PR/0665/22

Record of Executive Business and Chief Executive's Order

Reg. Reference: SD21A/0246 **Application Date:** 03-Sep-2021
Submission Type: Additional Information **Registration Date:** 06-May-2022

Proposed Development: Construction of 8 houses comprising of 1 three bedroom two storey detached, Type B1 (c. 122sq.m) Site 1, 1 four bedroom 2 storey detached type B2 (c.134sq.m) Site 2, 6 four bedroom 2 storey semi-detached Type A1 (c.148sq.m) Sites 3-8 inclusive, all associated on and off site development works ,landscaping ,boundary treatments, removal of existing street boundary screen wall and the provision of vehicular and pedestrian access to Grangebrook Avenue on infill site of circa 0.226 ha.

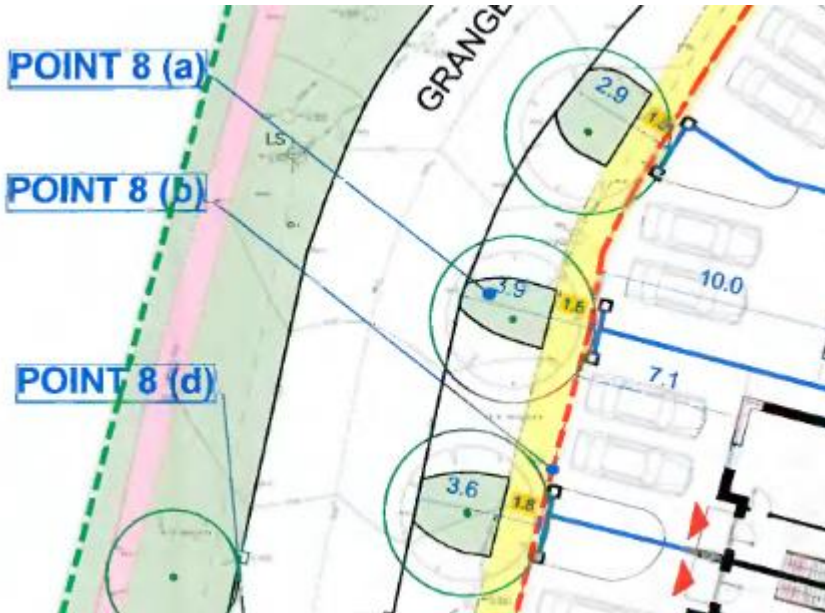
SDCC's Road Department have reviewed the additional information submitted and request clarification of additional information:

*Roads Department Assessment:
Response mainly ok but the inflection in the footpath's directions must be smoothed out.
Clarification required.*

- 1. As per 8(c); Applicant to submit a drawing showing smoothed inflection in footpath alignment.*
- 2. Proposed vehicular entrance widths are not dimensioned and seem to exceed the maximum width of 3.5m in most cases.
Applicant to submit a drawing showing vehicular entrance widths of 3.5m width or less for all proposed dwellings.*

*Roads Department Assessment:
Satisfactory response to 8 (a) & 8 (b)*

*Roads Department Assessment:
Satisfactory response to 8 (d) & (e)*
